9 August 2024

Shaun Williams
Senior Environmental Assessment Officer
Department of Planning, Housing and Infrastructure
Via the Major Projects Portal

RFI RESPONSE LETTER | SSD-36138263 AUGUSTA STREET, HUNTINGWOOD

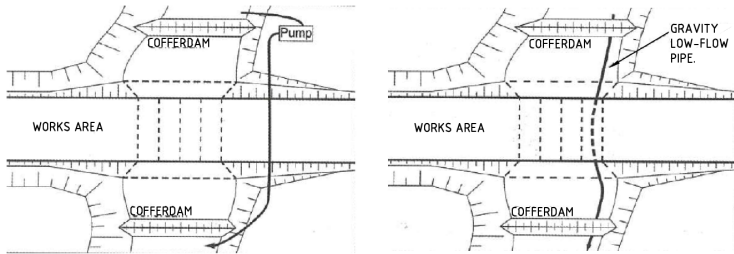
DPHI, email dated 27 June 2024 DPHI have been back through the EIS and RTS package and believe it would be beneficial if more information surrounding the temporary construction crossing could be provided. A covering letter format should be sufficient which pulls out all details on the proposed temporary construction crossing from the information	Information submitted to-date regarding the temporary Blacktown Creek crossings for construction purposes and associated mitigation measures are as follows: ▪ Engineering design and cofferdam arrangement for the instream works (shown in the figure below), inclusive of stream crossing, to ensure stormwater quality management.

Issue	Response
submitted to date including any images/figures, mitigation and management measures, and the assessed impacts.	 <u>PUMPED SYSTEM OPTION</u> <u>GRAVITY PIPE OPTION</u> <u>INSTREAM WORKS COFFERDAM ARRANGEMENT</u> ▪ Mitigation measures proposed for instream works include: – Erection of sediment fences and sediment fence returns prior to commencement of work. – Undertaking works during a period of dry forecasted weather. – Immediately plant the affected areas to stabilise the works. The two temporary crossings are also described in further detail below, as detailed in the Temporary Crossing Civil Engineering Memorandum: ▪ Temporary Crossing 1 (south of Blacktown Creek) follows an existing maintenance track across the creek. This crossing will remain in place until the wetland area is delivered in accordance with the proposed works. ▪ Temporary Crossing 2 (north of Blacktown Creek) will remain through the entire construction period until the future intersection with the Great Western Highway is completed.

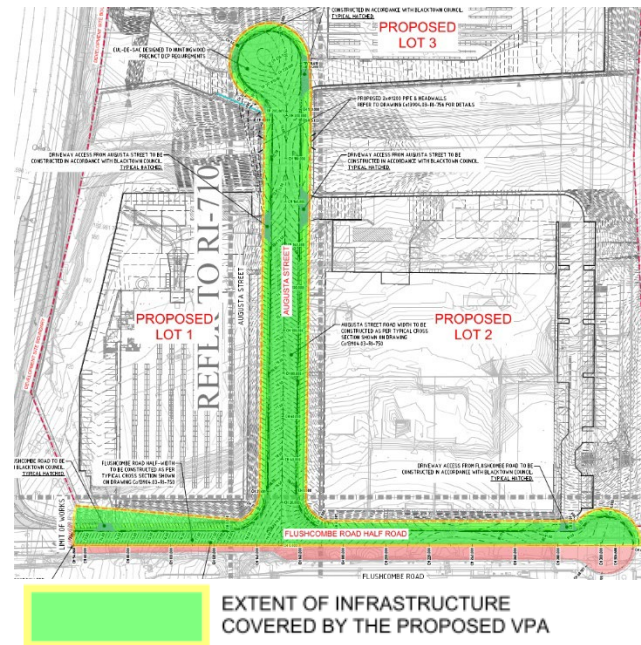
3. The revised plans have still not detailed turf cell permeable paving for the car parking area for Warehouses 5A to 5H as previously requested in item 2 of our submission dated 12 April 2024.	The Warehouse 5 car parking area does not include turf cell permeable paving as the car park is beyond the M4 Motorway 20m landscaped setback area for Warehouse 5. Further, the landscaping in and around the car parking area has been maximised with 6m tall canopy trees and a mix of low groundcover and screening shrubs to effectively minimise car parking hardstand.
<u>Engineering Issues</u> 1. The infrastructure to be covered by the VPA is to be provided so that the extent of the engineering works to be conditions by this consent can be ascertained.	The infrastructure covered by the planning agreement includes the boundary of both Flushcombe Road (the remaining half-road) and Augusta Street as per the following diagram.
